INTRODUCTION

Development Site

DESTROYS DISTRICT PLAN INTENT

Century Park District Node: Vehicle Oriented vs Pedestrian Oriented Land use in DC2 and CG Zoning.

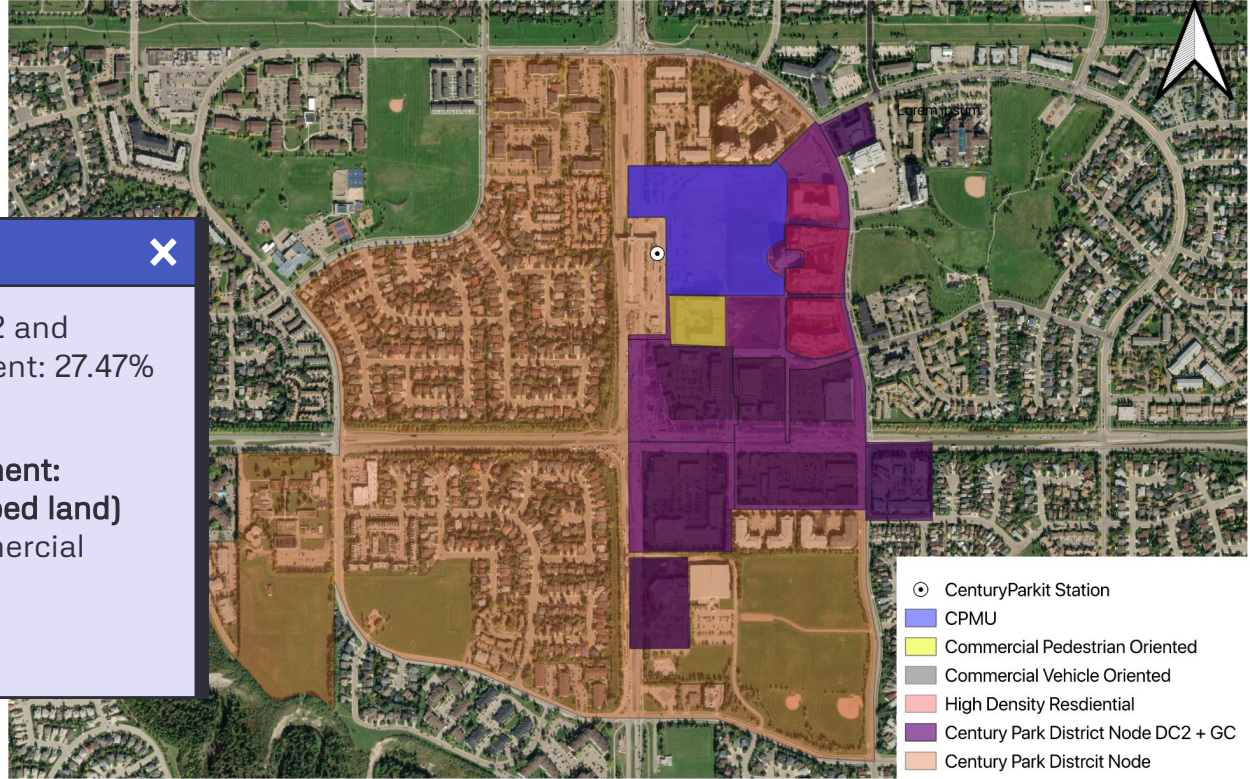
- Super cool that it's being developed
- Love the high density
- HOWEVER:
 1. Replacing the 'Main Street' with a more vehicle oriented 'Centre Street' perpetuates vehicle oriented development already in the area, and destroys the intent of the district's only Priority Growth Area
 2. Community engagement was insufficient

Century Park District Node DC2 and General Commercial Development: 27.47%

Within DC2 +CG Development:

- **Vehicle Oriented Development: 40.92% (50.15% of developed land)**
- Pedestrian Oriented Commercial Development: 3.00%
- High Density Residential Development: 9.79%
